**Additions and Renovations  
Platt Technical High School  
Milford, CT**

**ADDENDUM NO. 2**

July 29, 2019

1 FIRST FLOOR PLUMBING BELOW SLAB - AREA F  
 1/8" = 1'-0"  
 FFE: 07'  
 REFER TO DRAWING P3-1-1 FOR PLUMBING LEGENDS.  
 REFER TO DRAWING P3-1-2 FOR SCHEDULES & FIXTURE CONNECTION SCHEDULE.  
 REFER TO DRAWINGS P4-1-1, P4-2 & P4-3 FOR PLUMBING DETAILS.

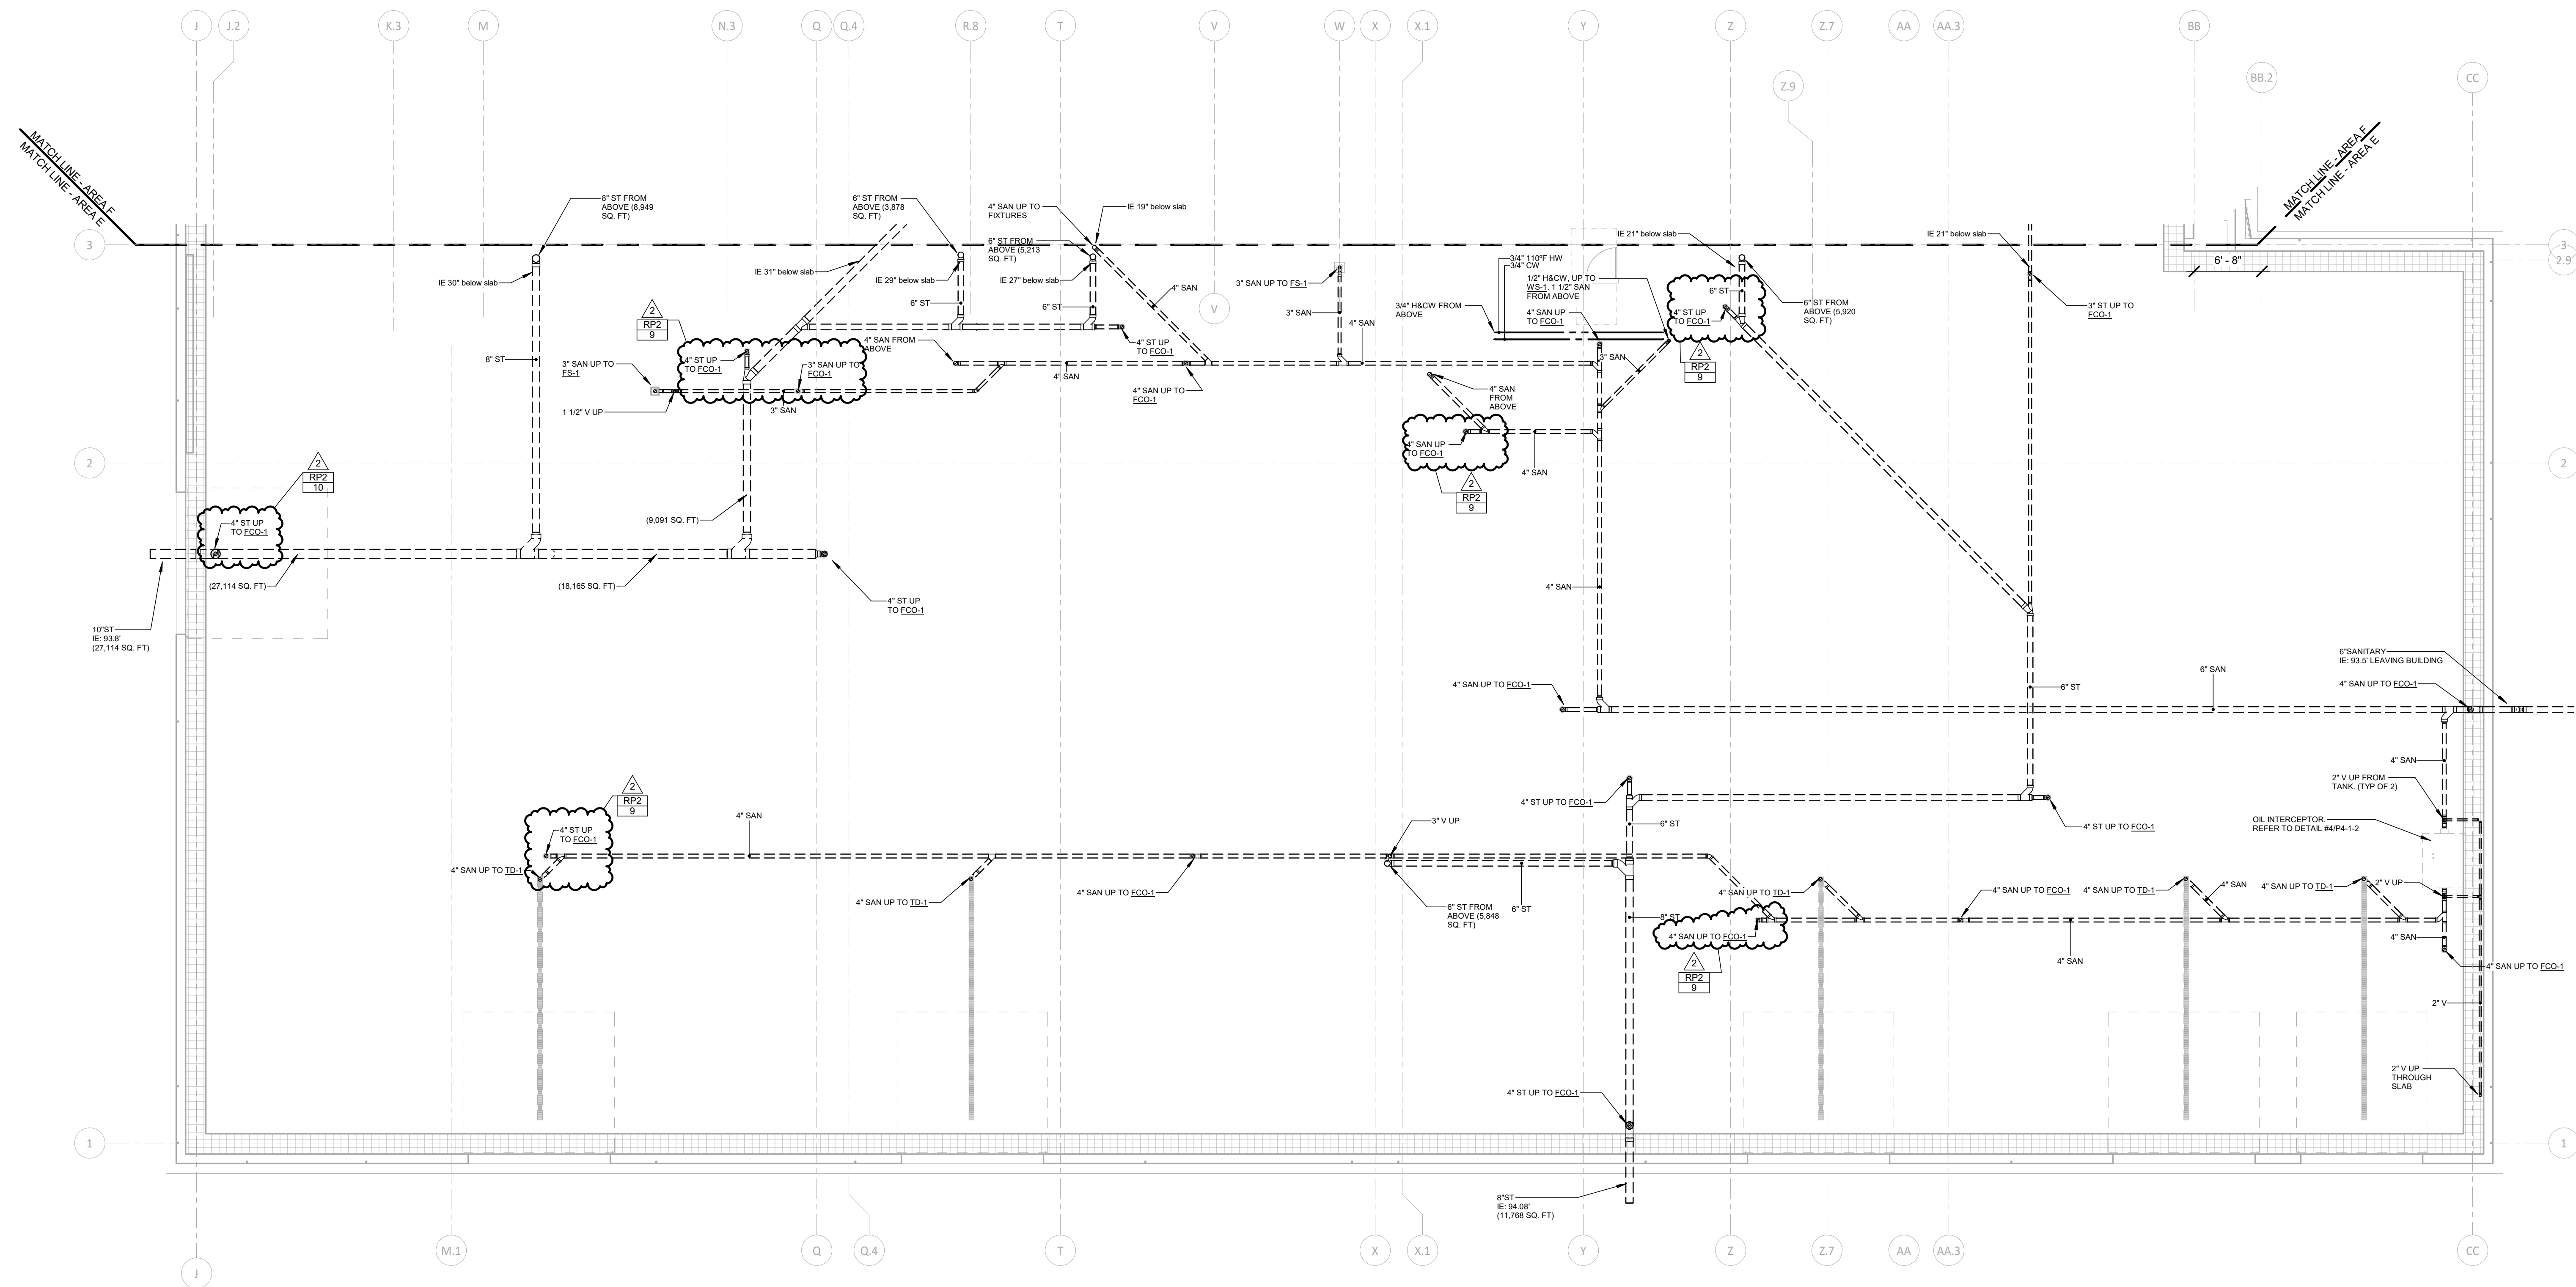
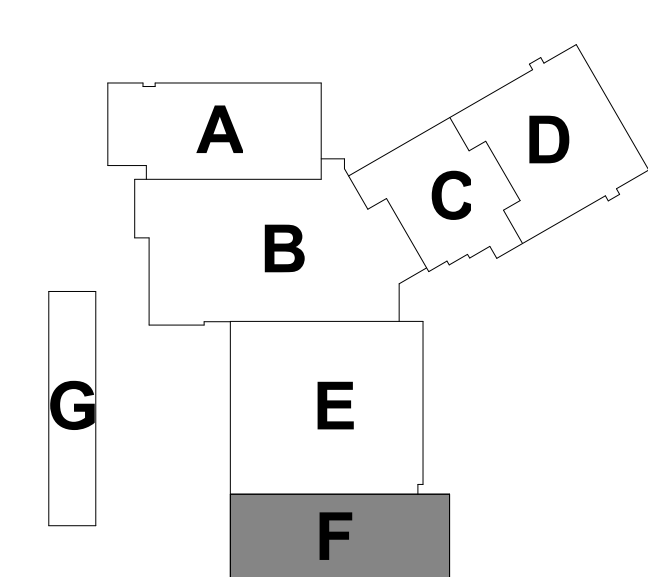
- ADD 2-024      DRAWING P1-1-UE – UNDERSLAB PLUMBING PLAN – AREA E**  
Added floor clean outs (FCO-1) and piping per Revision RP2-8.
- ADD 2-025      DRAWING P1-1-UF – UNDERSLAB PLUMBING PLAN – AREA F**  
Added floor clean outs (FCO-1) and piping per Revision RP2-9.  
Added floor clean out tag (FCO-1) per Revision RP2-10.

1 FIRST FLOOR PLUMBING PLAN - AREA A  
1/8" = 1'-0"

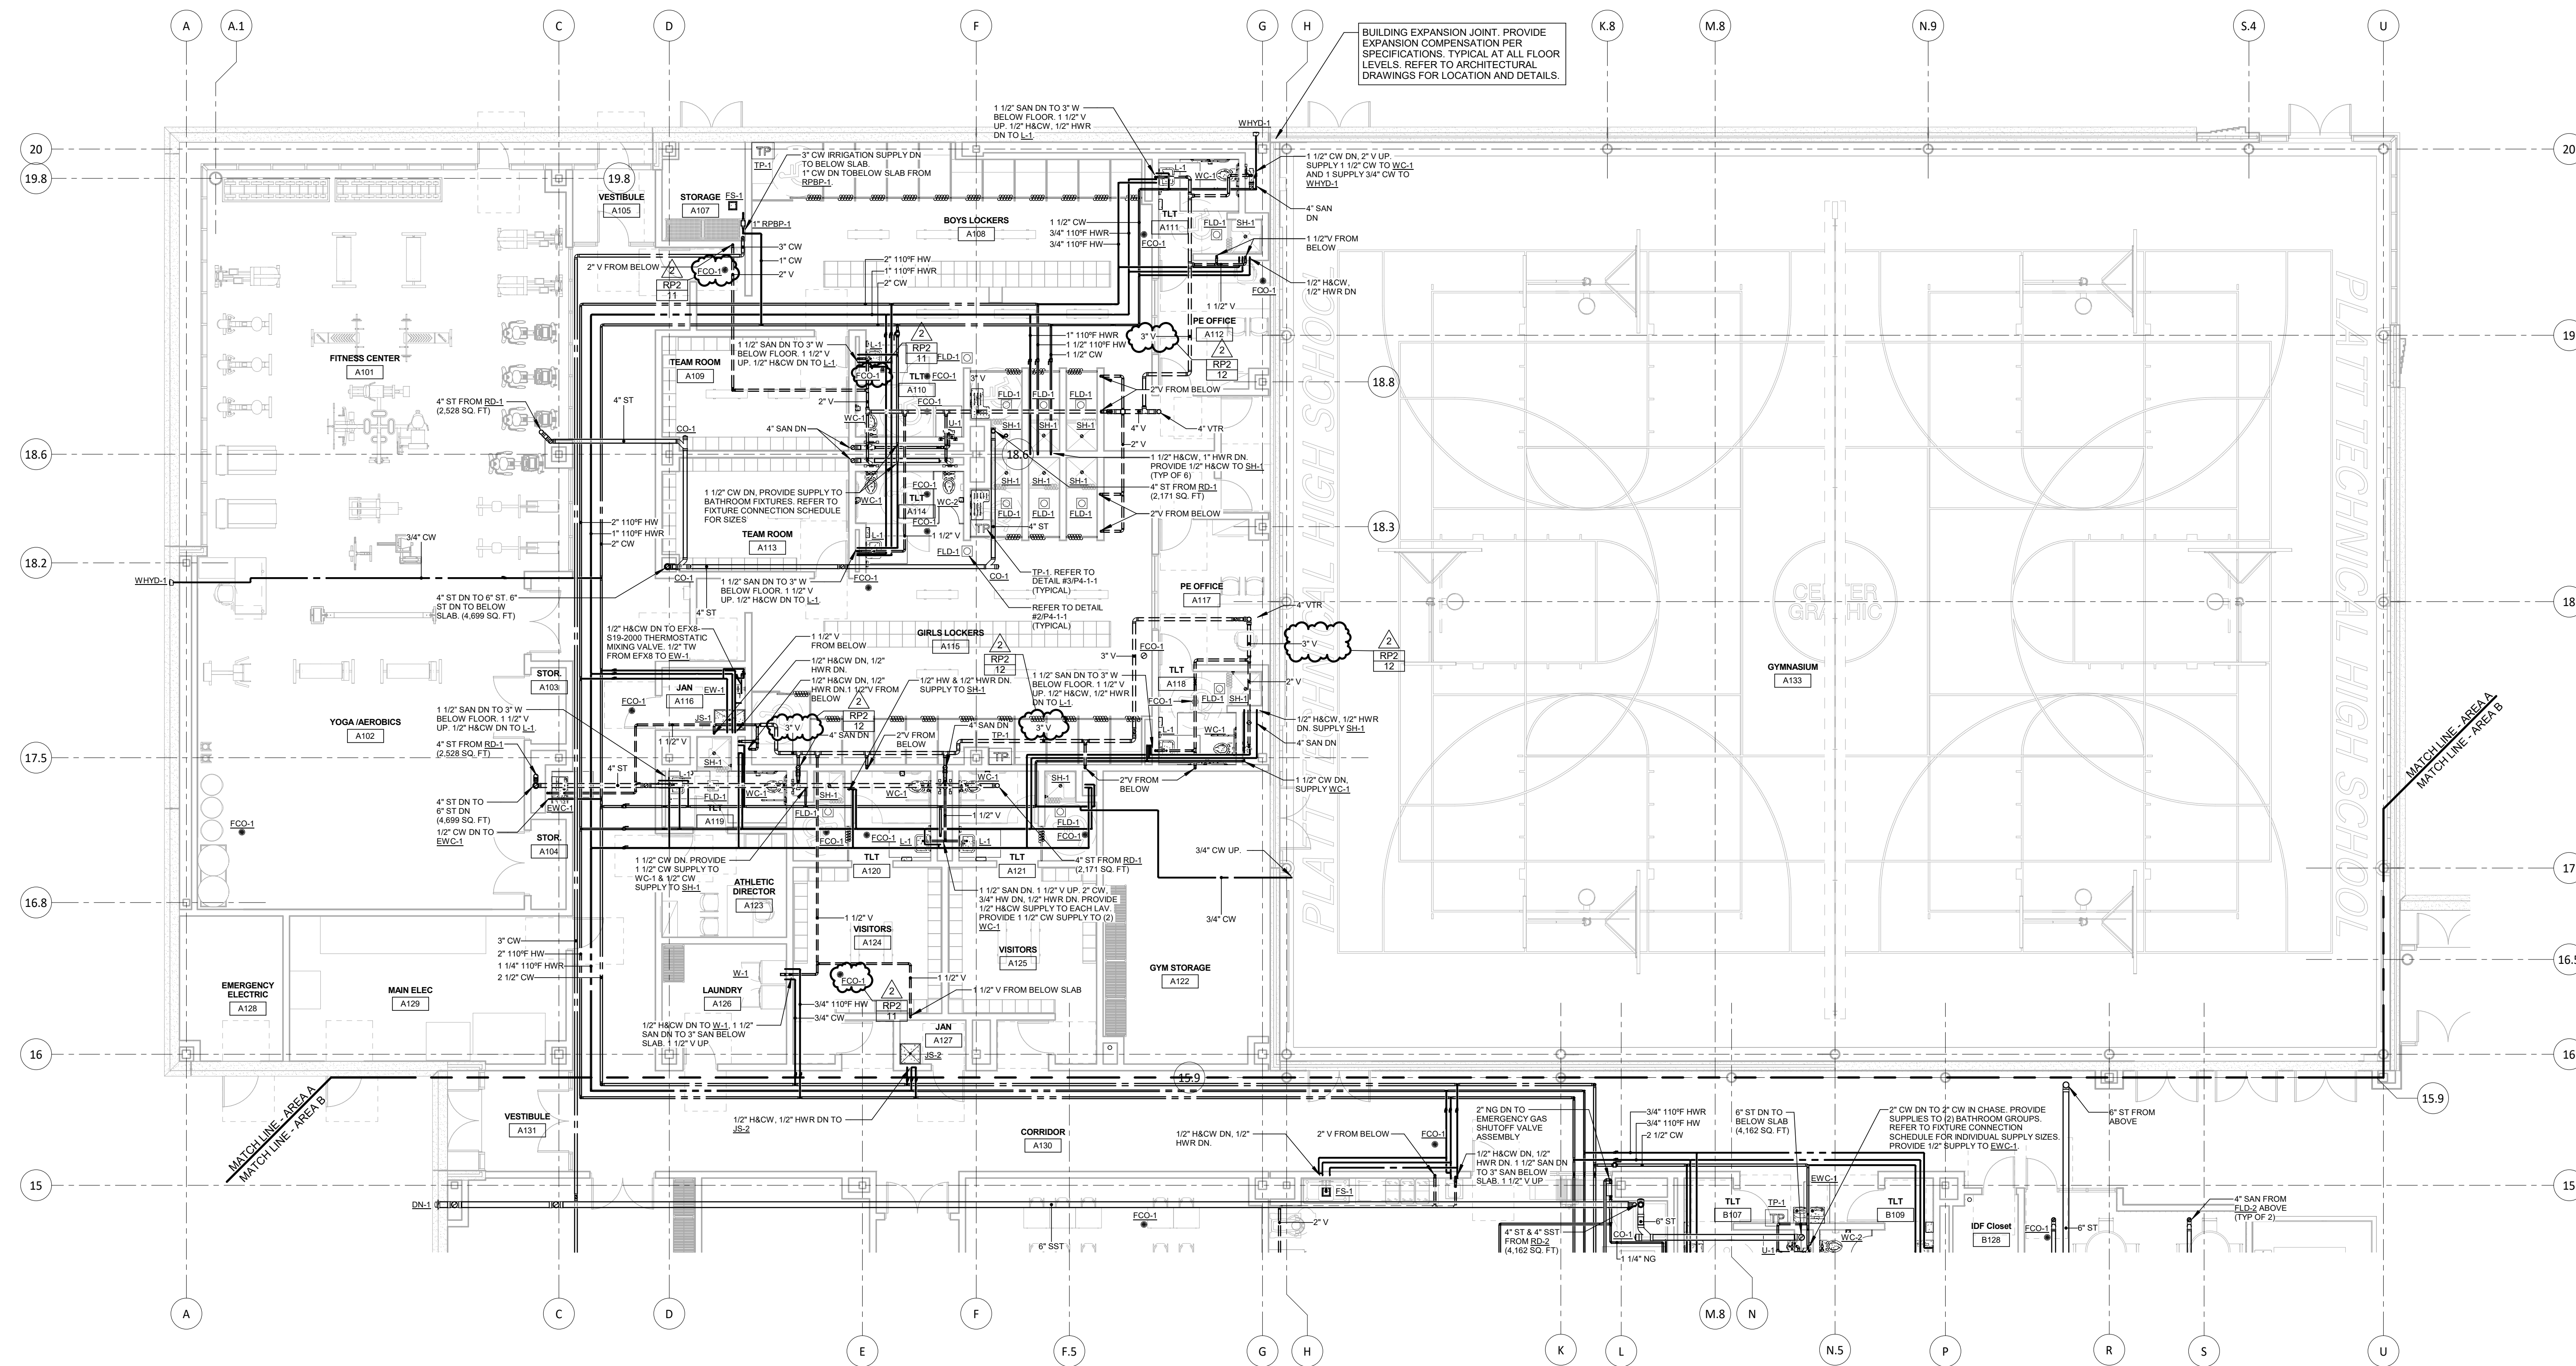
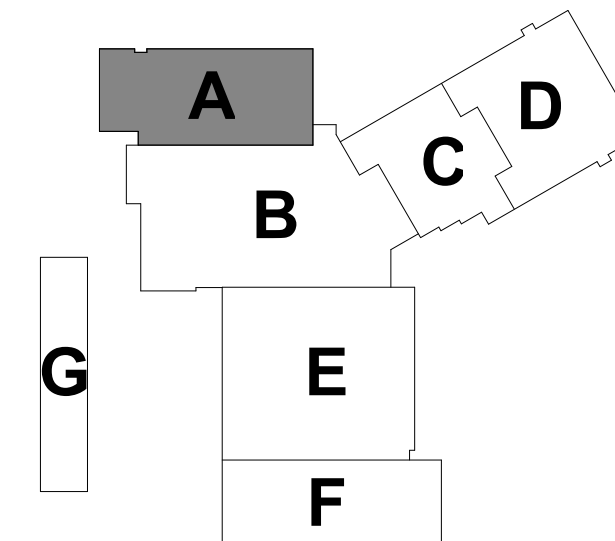
- ADD 2-026      DRAWING P1-1-1A – FIRST FLOOR PLUMBING PLAN – AREA A**  
Added floor clean outs (FCO-1). (SAME AS P1-1-UA) per Revision RP2-11.  
Modified vent piping from 2-1/2" to 3" per Revision RP2-12.
